BROWNS FERRY NUCLEAR PLANT (BFN) - UNITS 1, 2, AND 3 LICENSE  
RENEWAL APPLICATION (LRA) - RESPONSE TO NRC REQUEST FOR  
ADDITIONAL INFORMATION (RAI) CONCERNING FOLLOW-UP TO RAIs  
4.7.7-1 AND 4.7.7-2 (TAC NOS. MC1704, MC1705, AND MC1706)

TENNESSEE VALLEY AUTHORITY  
BROWNS FERRY NUCLEAR PLANT (BFN)  
UNITS 1, 2, AND 3  
LICENSE RENEWAL APPLICATION (LRA)

RESPONSE TO NRC REQUEST FOR ADDITIONAL INFORMATION (RAI)  
CONCERNING FOLLOW-UP TO RAIs 4.7.7-1 AND 4.7.7-2

Figure 2: Relationship of microstructural related radiation induced processes as a function of flux and temperature (from Scott, Reference 3). Note:  $10^{-8}$  dpa/s is equivalent to  $\sim 1 \times 10^{13}$  n/cm<sup>2</sup>/s.

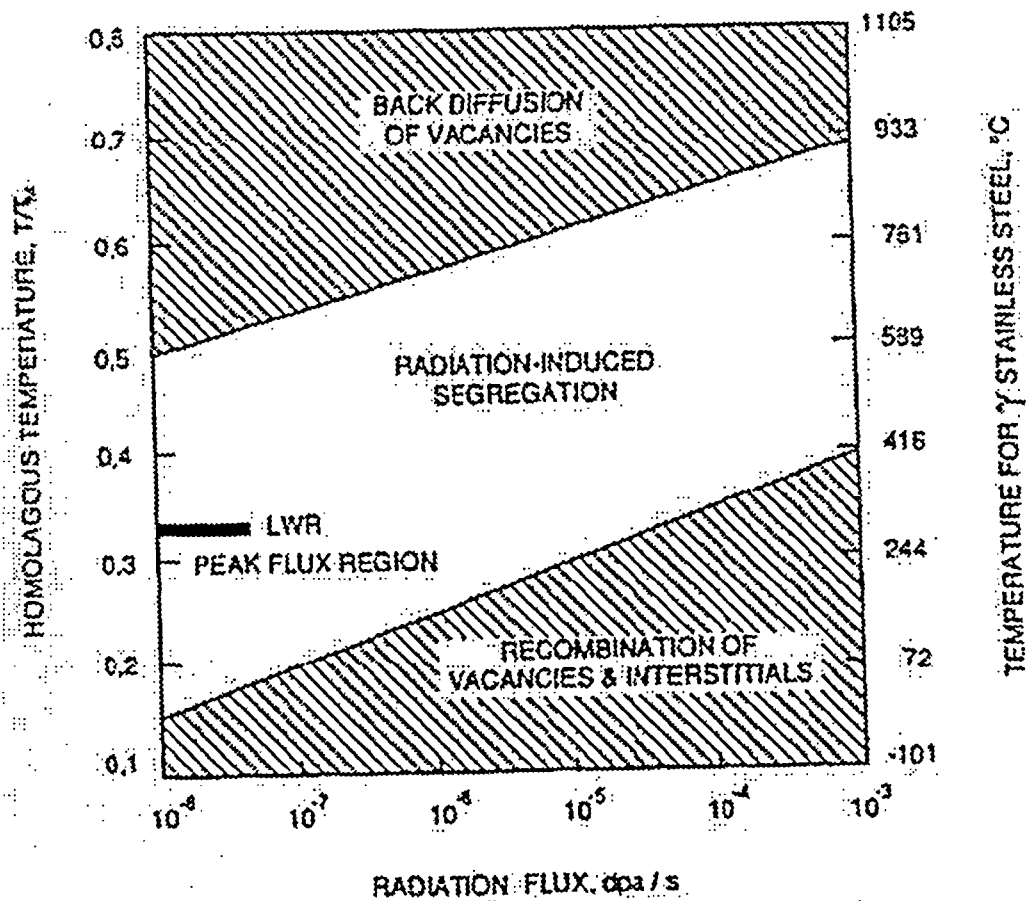
Figure 1 of the applicant's submittal dated June 29, 2005, compares the stress relaxation for the BFN core plate hold-down bolts, to the stress relaxation from the data derived from springs and bent beam stainless steel specimens. The staff request that the applicant provide information regarding the values of neutron flux and temperature at which the bent beam and spring test specimens were exposed, and compare them to the neutron flux and temperature values of the BFN's core plate hold-down bolts. If the neutron flux and temperature values for the BFN core plate hold-down bolts are different than that for the bent beam and spring test specimen data, evaluate the impact of these differences on the predicted stress relaxation values of the BFN core plate hold-down bolts.

Impact of the Temperature and Flux Differences on the Core Plate Bolts: As stated above, the temperature data were very representative of the BFN core plate bolts. The neutron flux data, however, were measured in specimens subjected to fluxes ranging from  $\sim 1 \times 10^{13}$  to  $2 \times 10^{17}$  n/cm<sup>2</sup>/s. This is higher than the  $2 \times 10^{10}$  n/cm<sup>2</sup>/s average flux experienced by the BFN core plate bolts themselves. Given the large range of higher flux for which the properties are the same, the impact of the lower flux to which the bolts are exposed is viewed to be negligible. This is supported in greater detail in the following section.

Technical Support for the Use of the Current Stress Relaxation Data to Evaluate Core Plate Bolt Relaxation: The effect of radiation on microstructure is the driving force for stress relaxation with neutron fluence. The primary effect of radiation is to harden the material through the creation of vacancy and interstitial defects in the crystal lattice. These defects affect creep and segregation within the material which will increase the strength, produce stress

relaxation and lead to very narrow changes in the local composition at grain boundaries (Reference 2). The actual evolution of the microstructure is a complex process. Additionally, the data on materials under Light Water Reactor (LWR) conditions {i.e., temperature less than 350°C (662°F), fluences in the 0.5 to 5 dpa ( $\sim 6 \times 10^{19}$  to  $\sim 6.6 \times 10^{20}$  n/cm<sup>2</sup>) and attributable to a LWR neutron spectrum} is limited (Reference 3). Below this fluence level, degradation is just starting to occur. Following a short-term transient, the creep strain at constant load is very linear with fluence (which in turn is integrated flux over time) (Reference 4). Scott showed that the LWR operating flux/temperature region is one broadly associated with processes of limited microstructural dimension that in turn is associated with radiation-induced segregation (RIS) (Figure 2) (Reference 3). The continuity of these processes to lower flux levels is very much implied by Figure 2 for LWR material changes. Therefore, extrapolation of the higher flux data to the core plate region is fully justified and appropriate. Consistent with other microstructural processes, higher temperature and higher fluxes would be expected to produce bigger changes. The lower flux conditions would produce no additional effect on the relaxation behavior.
